TRANS/WP.29/GRSG/2003/22/Rev.2
20 August 2004

PROPOSAL FOR SUPPLEMENT 1 TO THE DRAFT 02 SERIES OF AMENDMENTS TO
REGULATION No. 107

(M2 and M3 vehicles)

Transmitted by the expert from the International Organization
of Motor Vehicle Manufacturers (OICA)

"Figure 1
ACCESS TO SERVICE DOORS

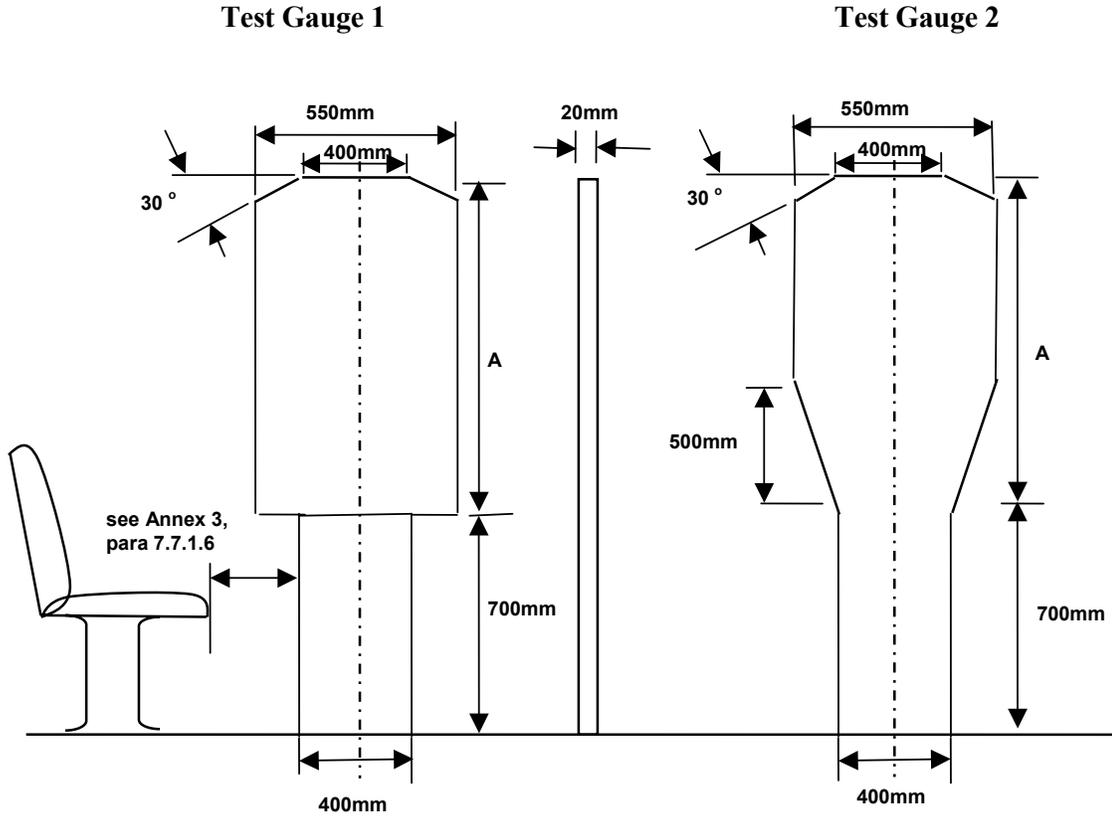
Figure 1, amend to read:

Vehicle Class	Height of the upper panel (mm) (Dimension 'A' figure 1)	
	Test gauge 1	Test gauge 2
Class A	950 (*)	950
Class B	700 (*)	950
Class I	1100	1100
Class II	950	1100
Class III	850	1100

(*) For vehicles of Class A or B, the lower panel may be displaced horizontally relative to the upper panel provided that it is in the same direction."

"Figure 11b

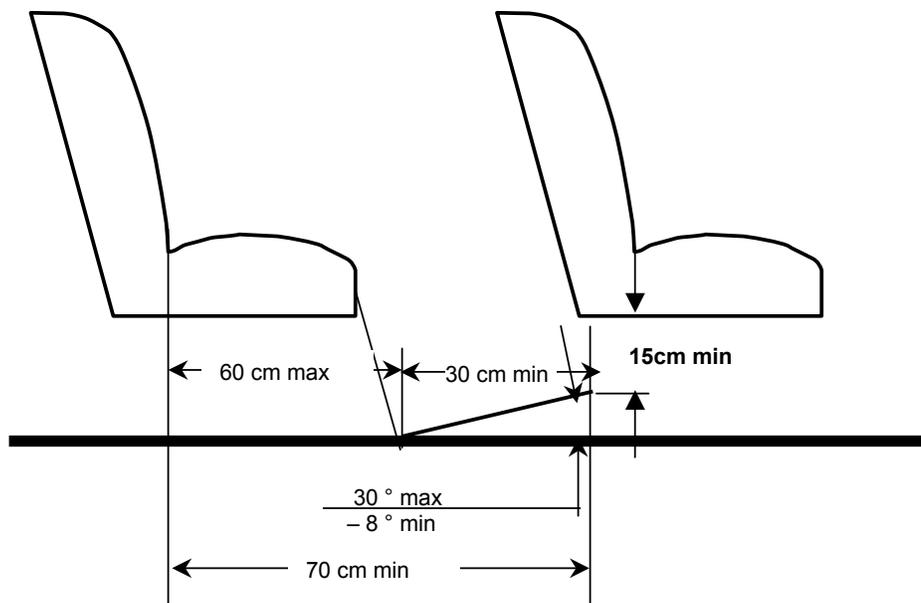
Insert a new figure 11b, to read:

**SPACE FOR FEET OF SEATED PASSENGERS BEHIND A SEAT AND OR/OR A SEAT
FACING THE GANGWAY
(see Annex 3, paragraph 7.7.8.5.2.)**

"Figure 27

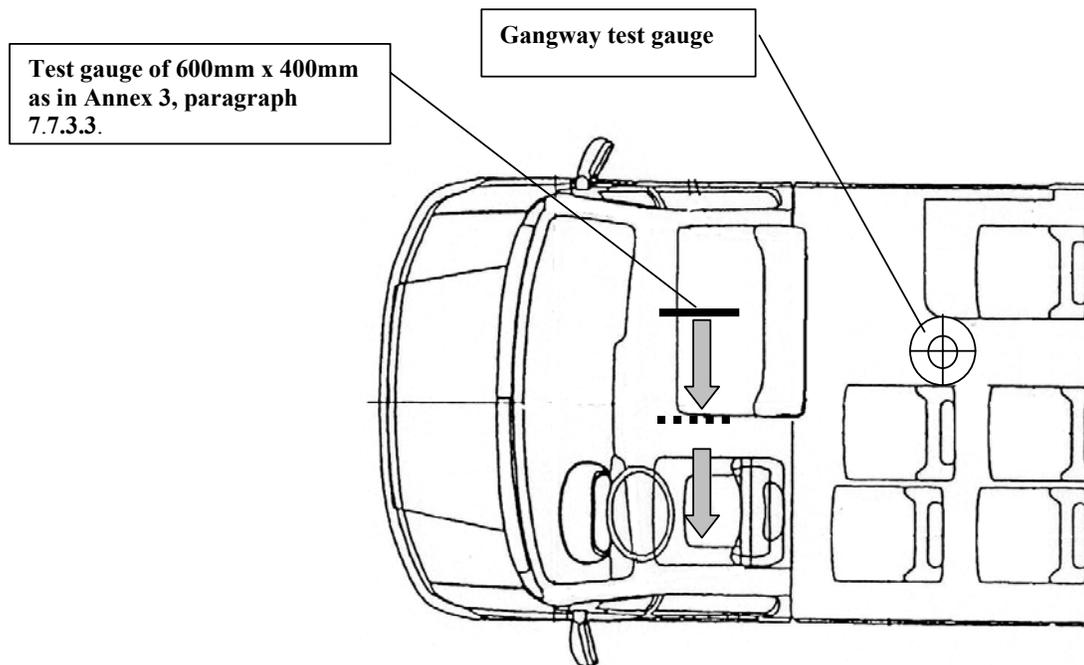
Insert new Figures 27 and 28, to read:

**ACCESS TO DRIVER'S DOOR
(See Annex 3, paragraph 7.6.1.7.2.)**
